**FCPS NEW MIDDLE SCHOOL – POLO CLUB**  
**KDE BG # 21-176**  
**FCPS BID # 20-21**  
**JRA Project No. 202078**  
Fayette County Public Schools  
Lexington, Kentucky

The Addendum will form a part of the Contract Documents and modifies the original Bidding Documents dated September 2021.

**G GUARDRAIL-HANDRAIL**  
SCALE: 3/4" = 1'-0"

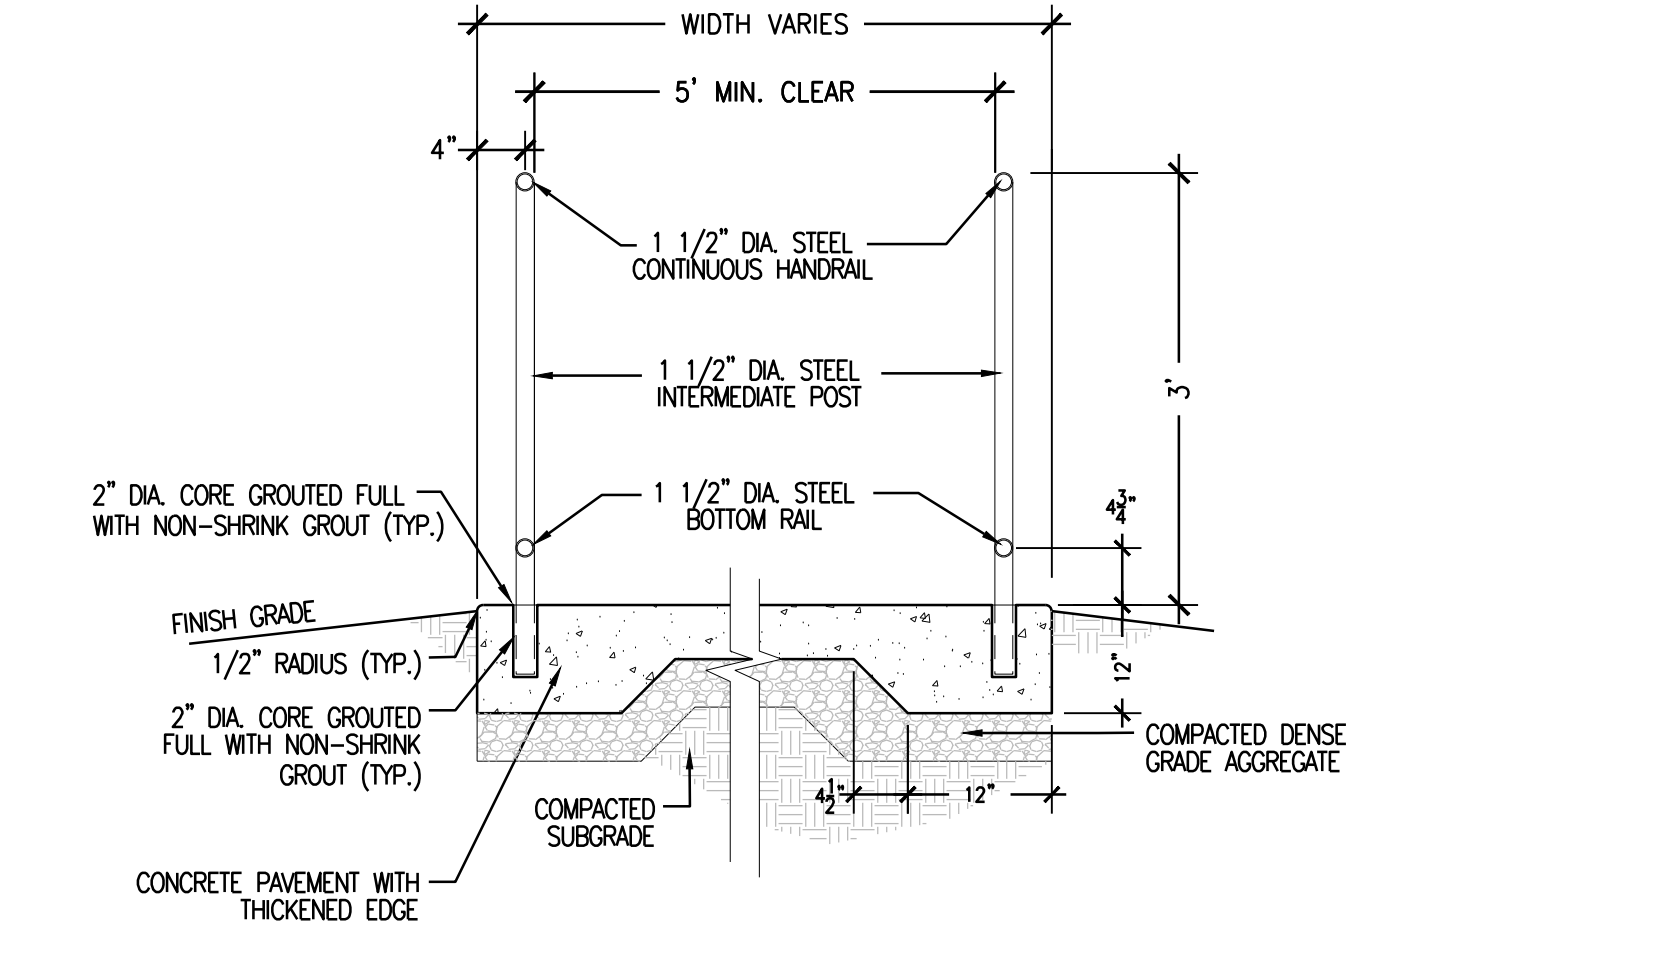
Refer to attached Sheet C-601.1, Site Details. Revise Detail G as shown.

**F CONCRETE SEAT WALL - RETAINING CONDITION**  
SCALE: 3/4" = 1'-0"

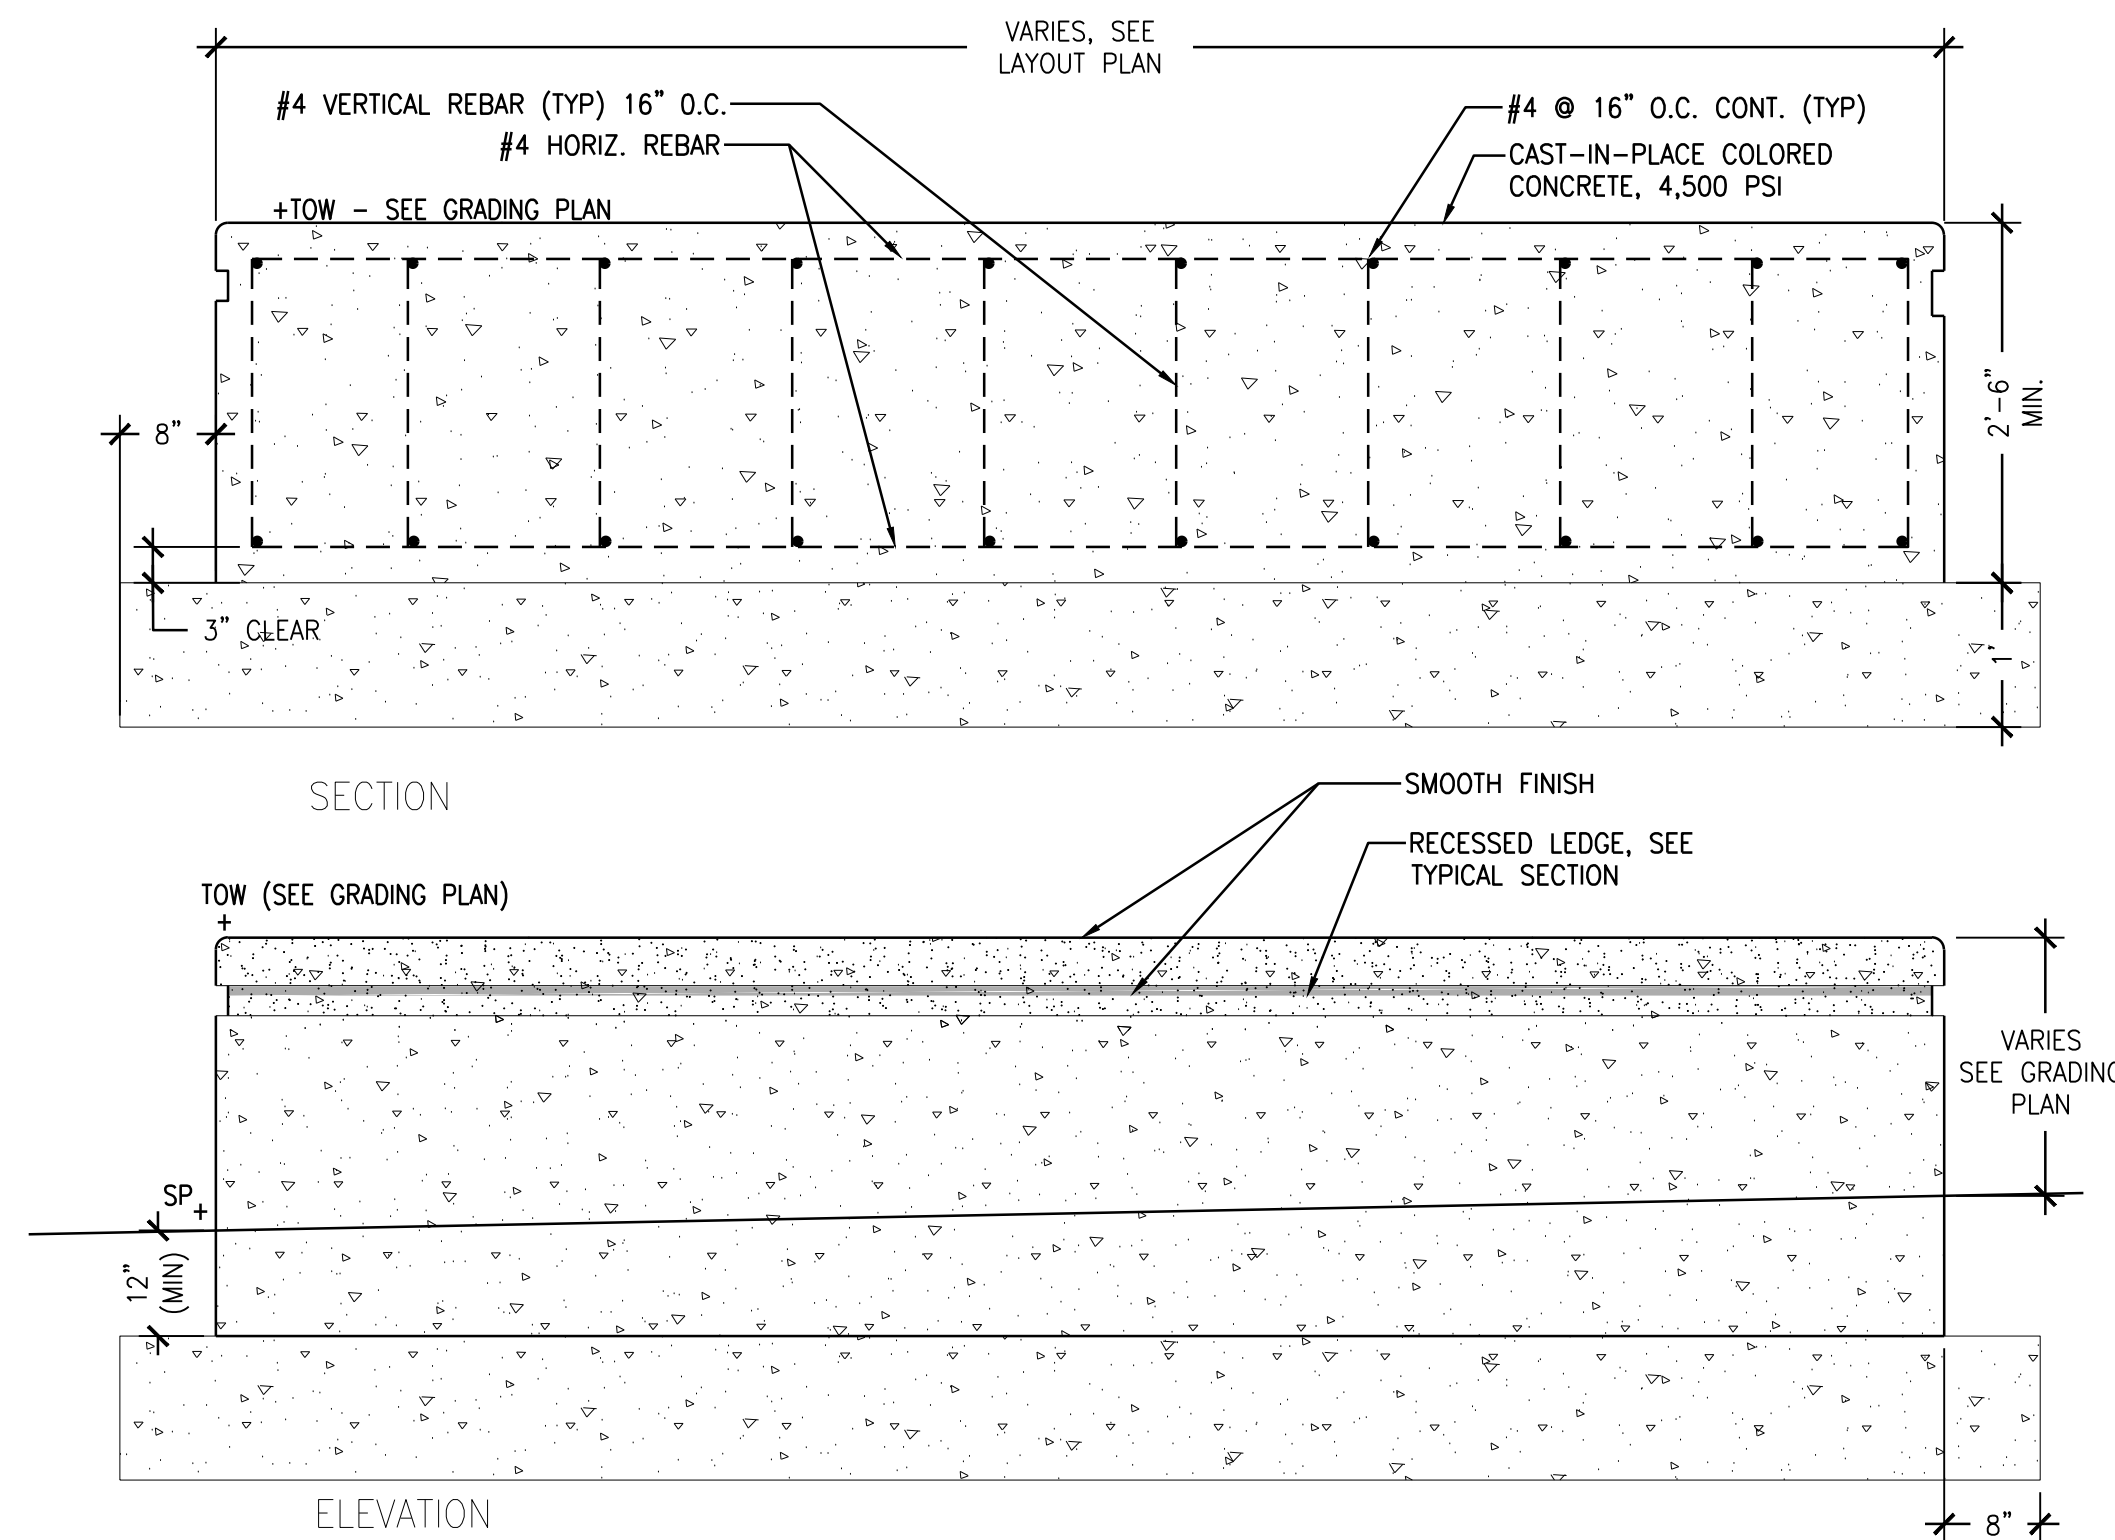
Refer to attached Sheet C-602.1, Site Details. Revise Detail F as shown.
